Drain-Improvement: SARAH MORGAN - HEATHER POINTE RELOCATION

Re: Sarah Morgan Drain - Heather Pointe
Relocation

STORM AS-BUILT
HEATHER POINT - SECTION ONE
 PARCEL 22 - HAMILTON PROPER
 FISHERS, INDIANA

SHEET TITLE: **STORM SEWER PLAN & PROFILES**
 PROJECT NAME: **HEATHER POINTE - SECTION ONE**
 PARCEL 22 - HAMILTON PROPER
 FISHERS, INDIANA

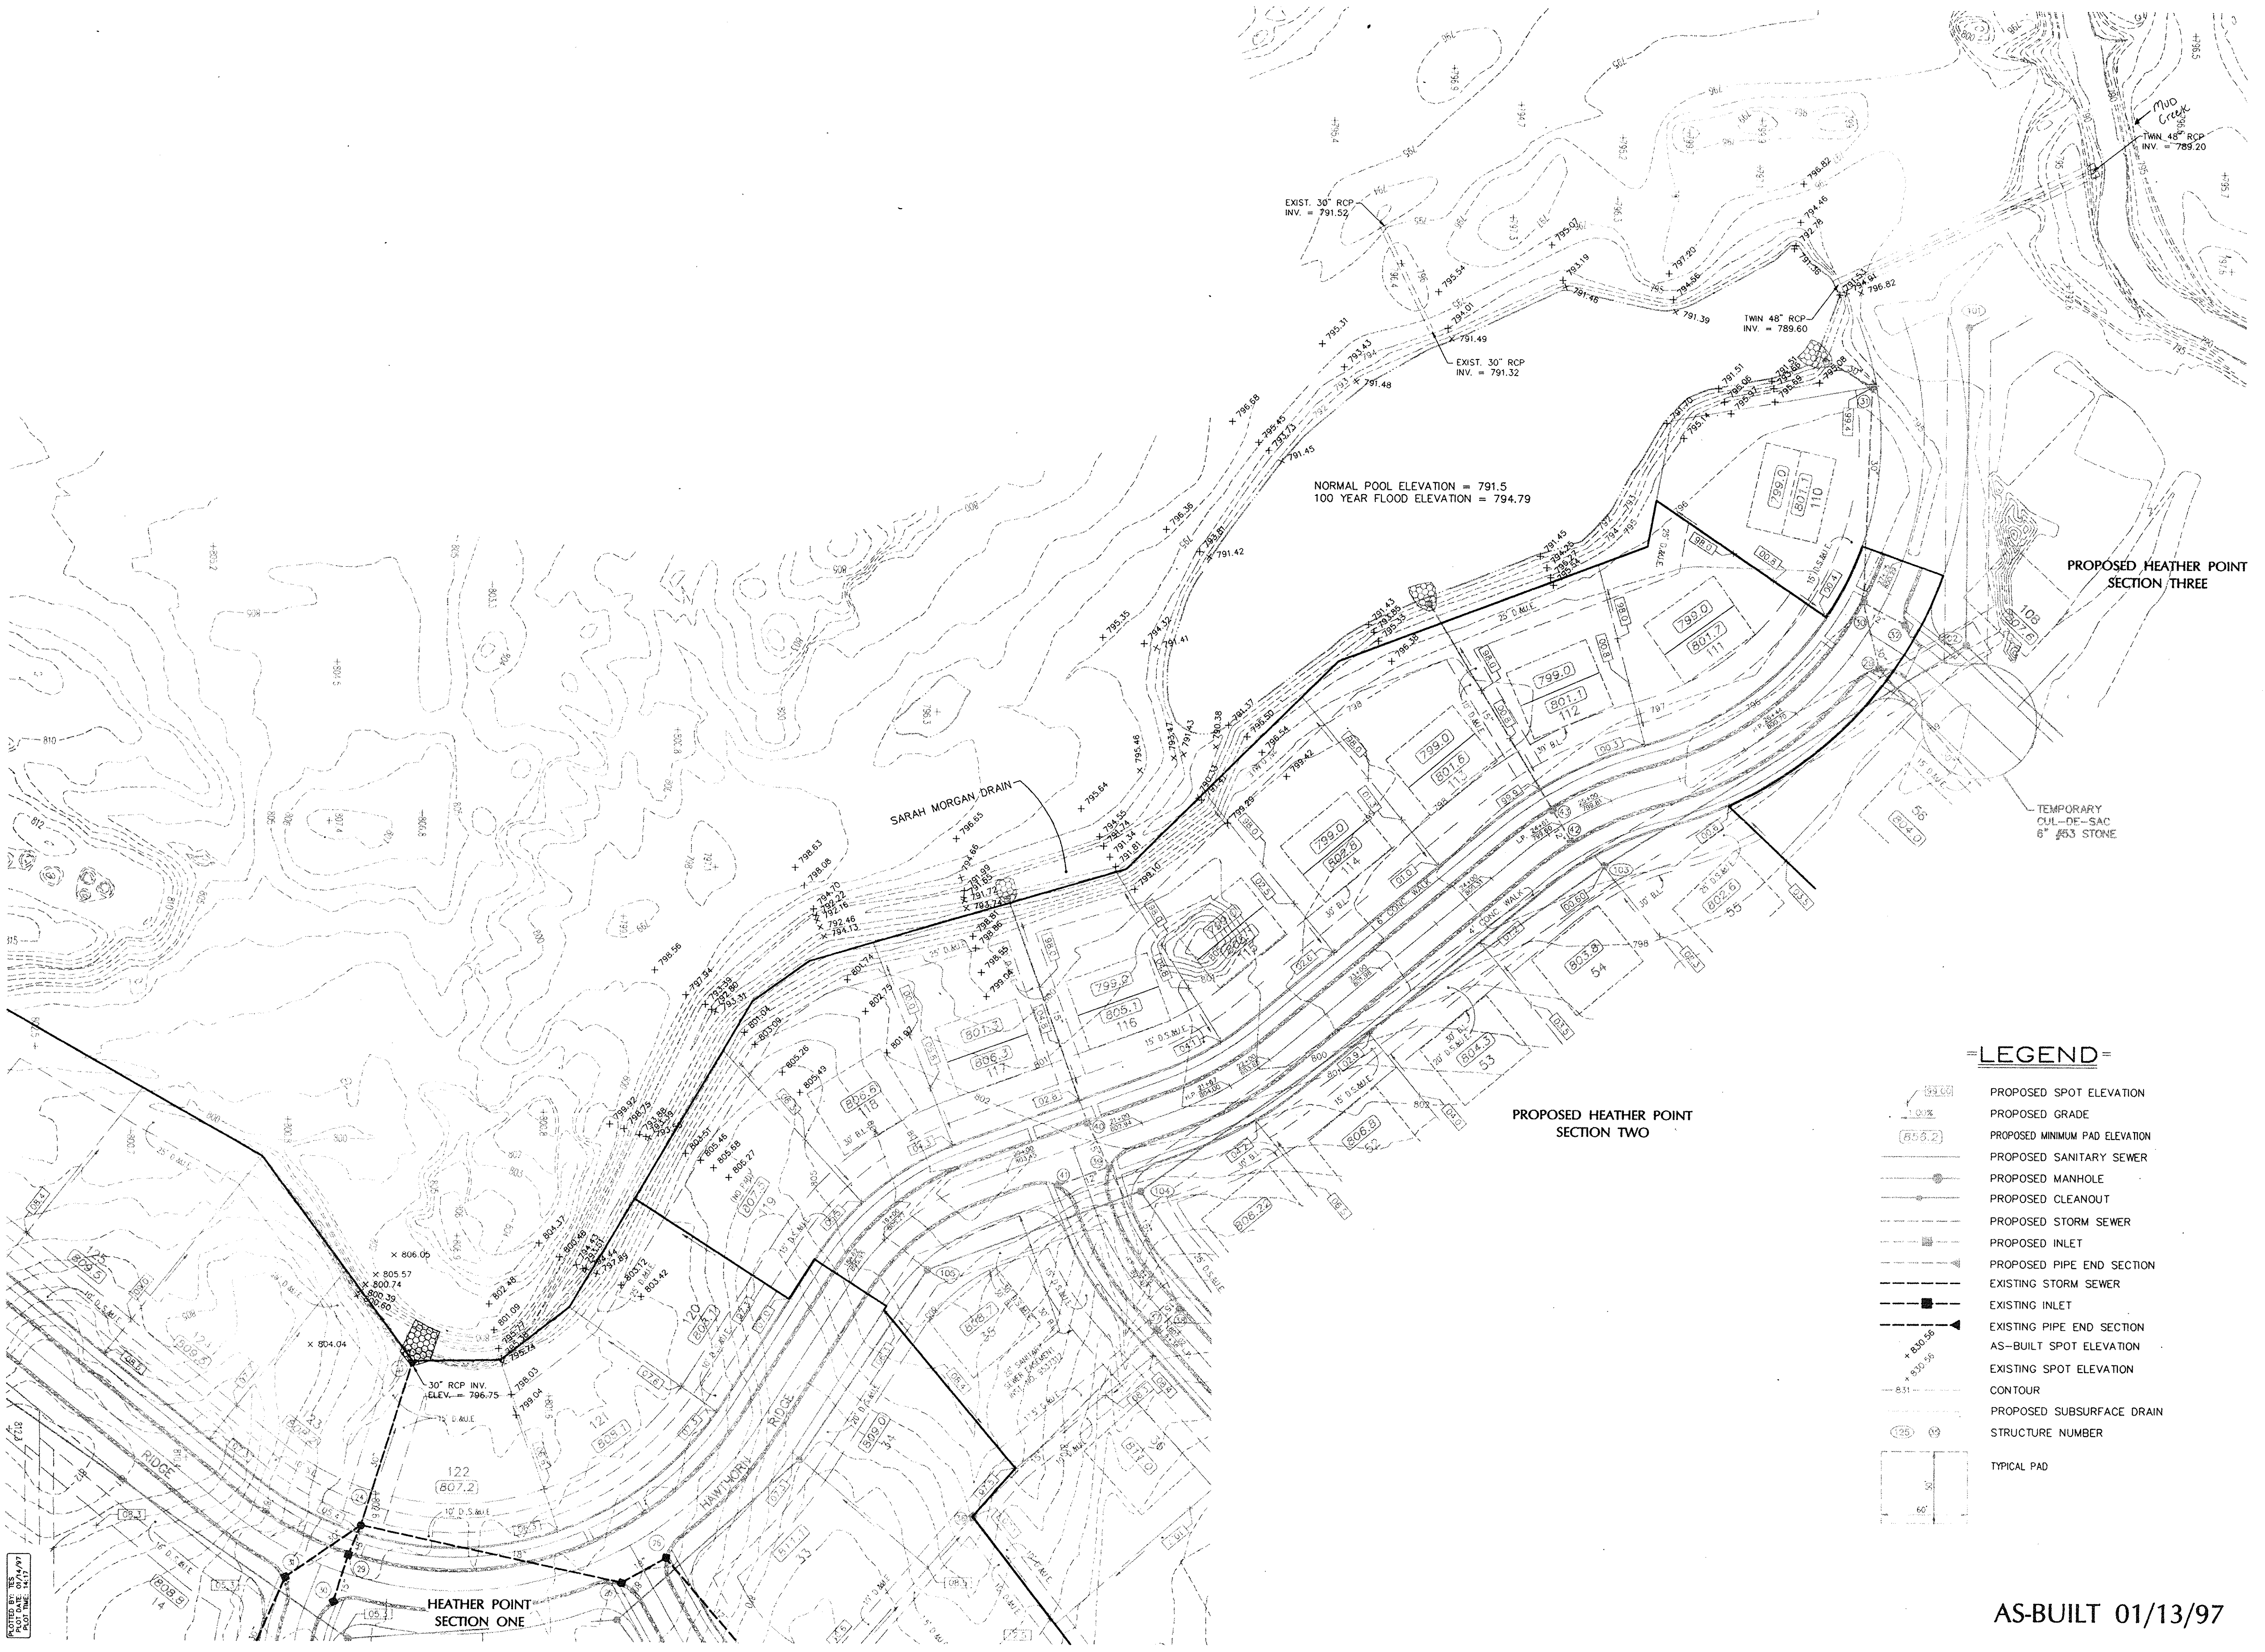
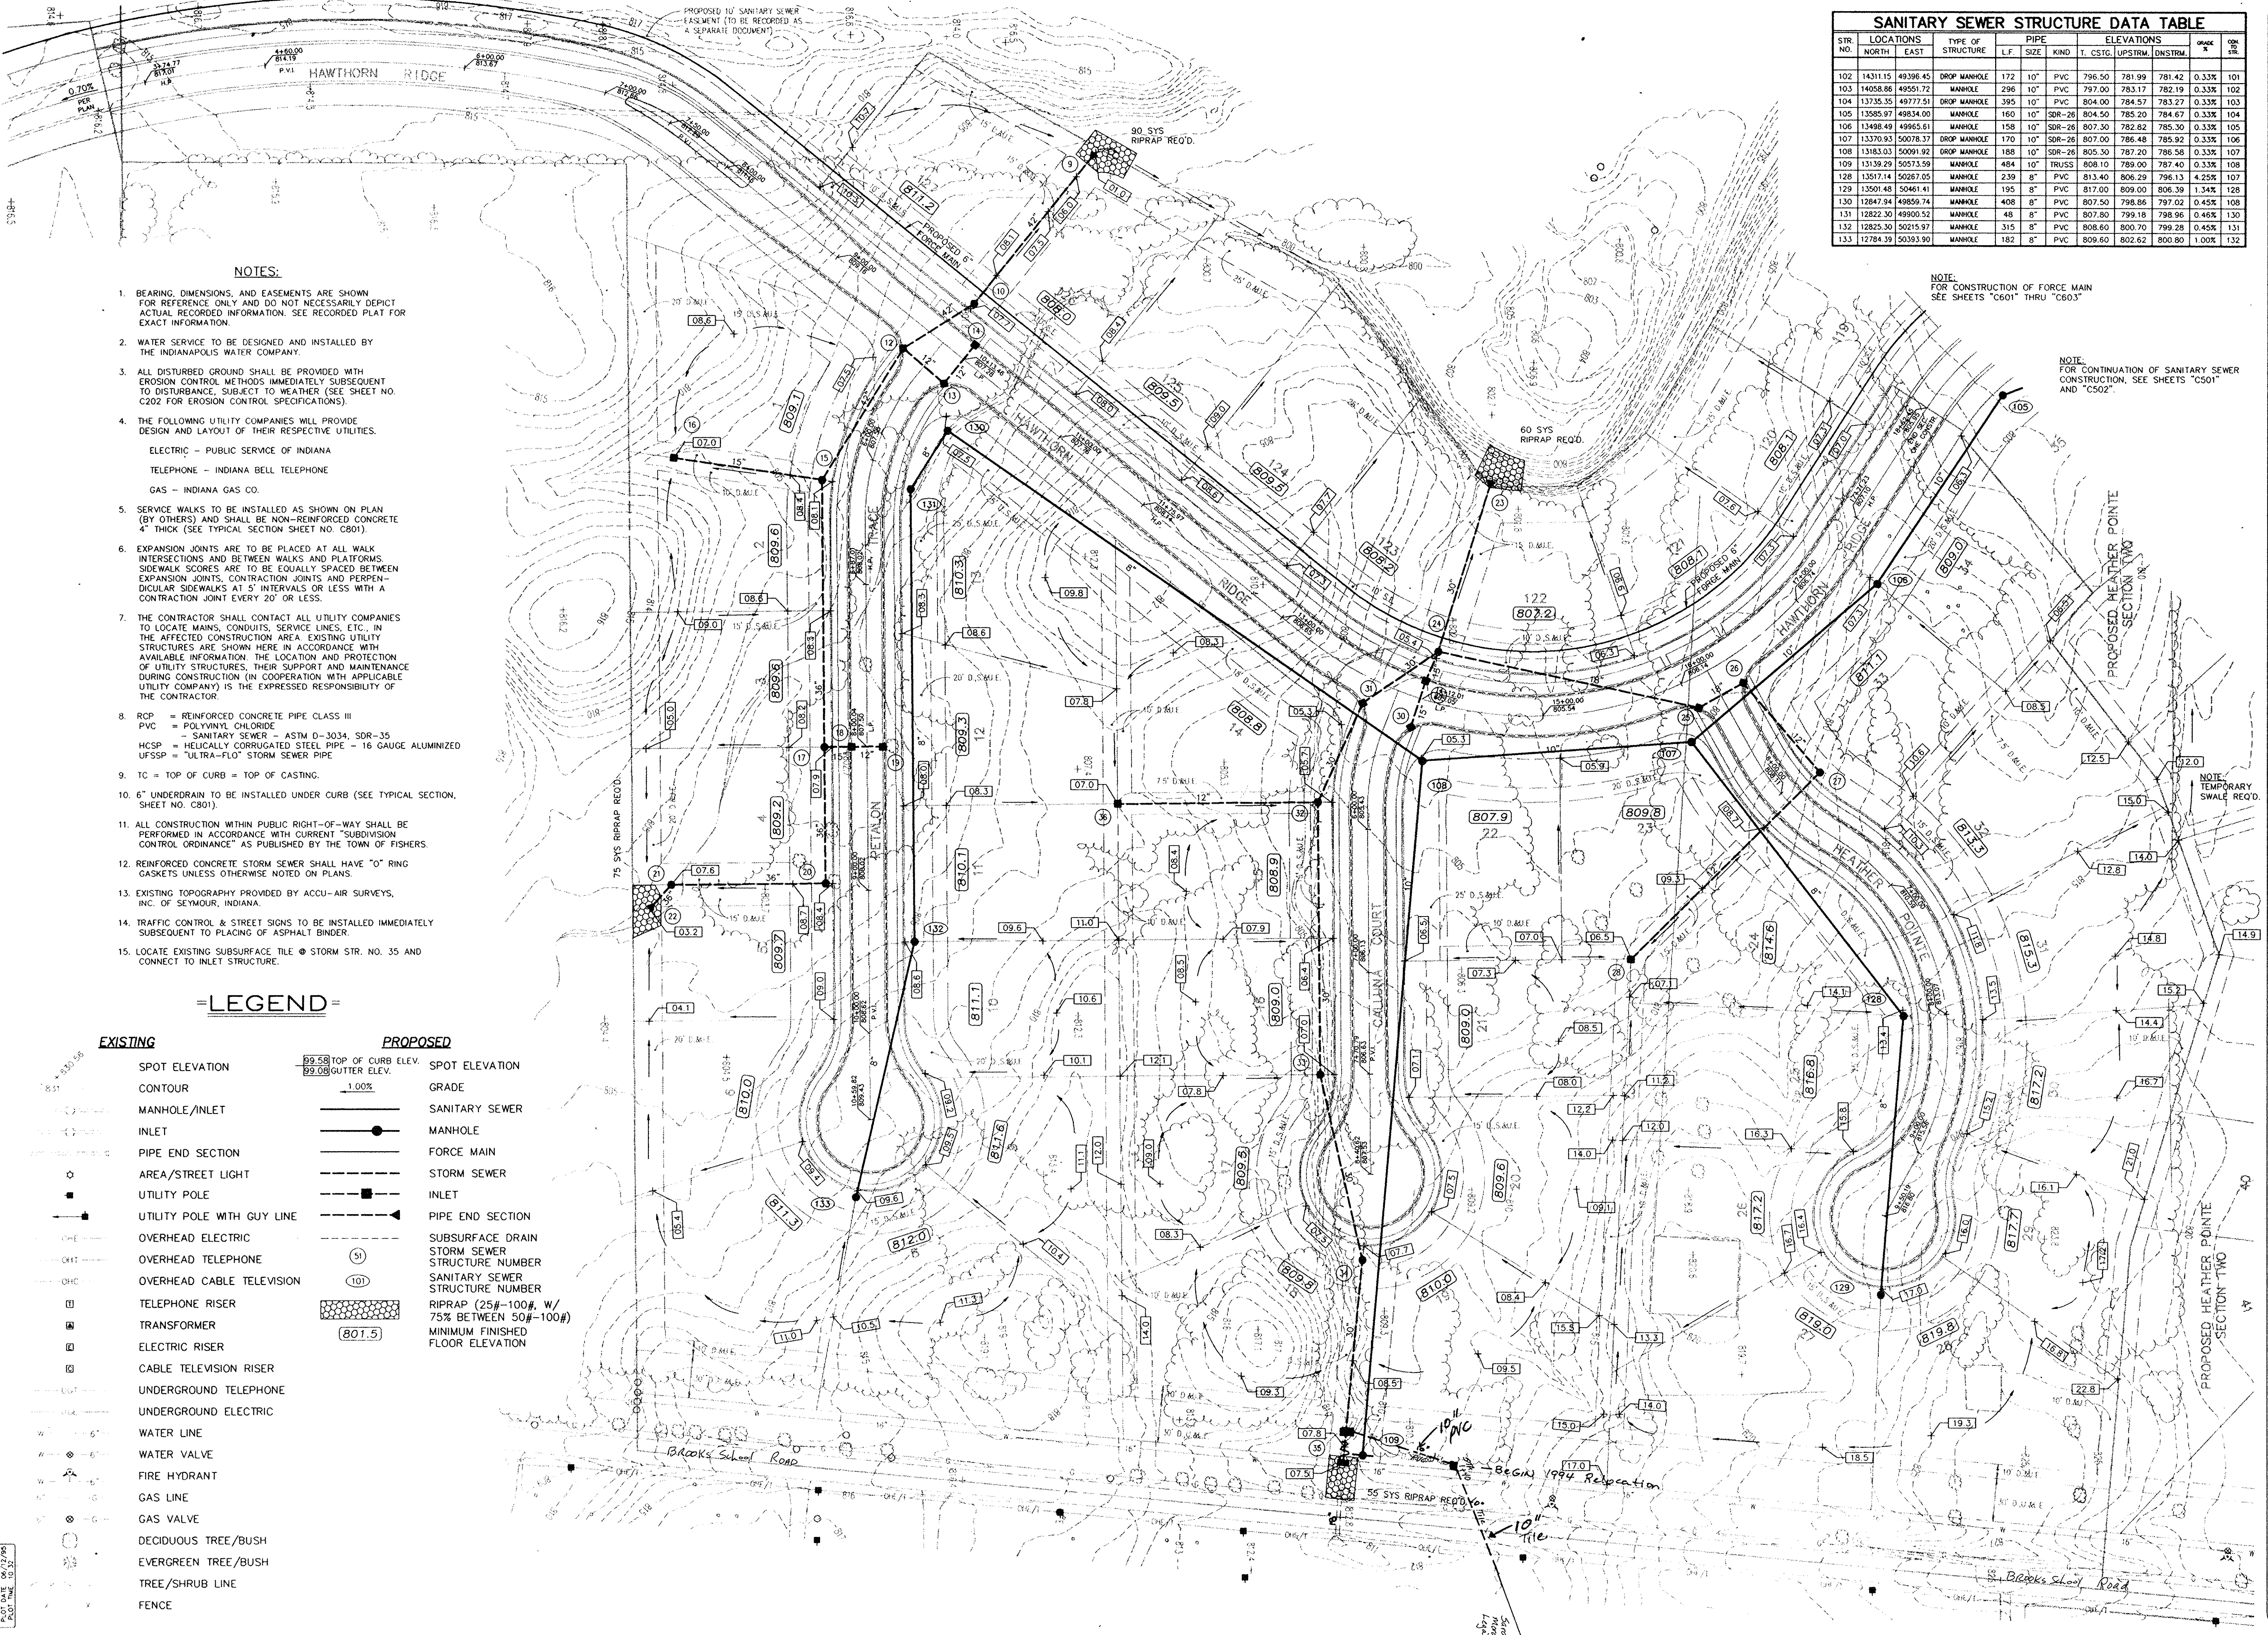
During construction, changes were made to the drain which will alter the plans submitted with my report for this drain dated August 22, 1994. The changes are as follows:

Str 24 - Str 31 30" RCP lengthened from 64' feet to 66' feet.

Str 31 - Str 32 30" RCP shortened from 75' feet to 73' feet.

Str 33 - Str 34 30" RCP lengthened from 133' feet to 135' feet.

Str 34 - Str 35 30" RCP shortened from 140' feet to 125' feet.

There was an inlet set on the existing Sarah Morgan Drain at Station 1+40 and from this structure 76' feet of 10" PVC was installed to structure 35.

The length of the drain, including the original 140 feet of drain, and the changes described above is now **1,835 feet**.
